# SYDNEY WESTERN CITY PLANNING PANEL

## COUNCIL ASSESSMENT REPORT

SSWPP No	2017SSW034
DA Number	DA-284/2017
Local Government Area	Liverpool City Council
Proposed Development	<p>Concept development application pursuant to section 4.22 of the Environmental Planning &amp; Assessment Act for a future mixed use development including commercial, business/retail, medical facility, child care centre and residential floor space, and parking.</p> <p>This application is for a concept approval only and seeks approval for site layout, location of future buildings, vehicular access, maximum building envelopes including setbacks and height, maximum gross floor area (GFA) across the site and location and maximum number of car spaces.</p> <p>Liverpool City Council is the assessment authority and the Sydney Western City Planning Panel has the function of determining the application</p>
Street Address	1-5 Speed Street Liverpool
Owner	Mount Pritchard and District Community Club and Mr Momir Dubocanin,

Concept development application pursuant to section 4.22 of the Environmental Planning & Assessment Act for a future mixed use development including commercial, business/retail, medical facility, chil

**Figure 9: Podium height**

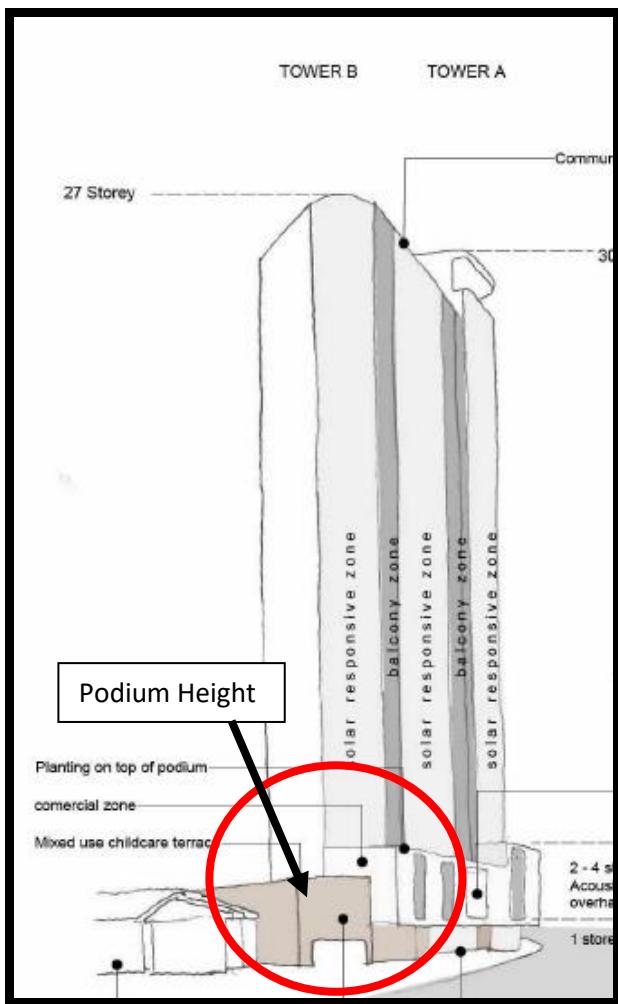
After subsequent amendments to the concept plan including the lowering of the podium element directly adjoining the item, the application was deemed satisfactory by Councils Heritage Officer and the Liverpool Design Excellence Panel. Further consideration of materiality and design in response to the Heritage item will be considered with future development applications for the built form.

The building envelope plan below indicates how the podium of the tower closest to the heritage item has been lowered to 2 storeys in height to respond to the scale of the item. Based on the information above it is considered that Clause 5.10 has been satisfied at this stage, with further consideration to be given when the applications for the built form are lodged.
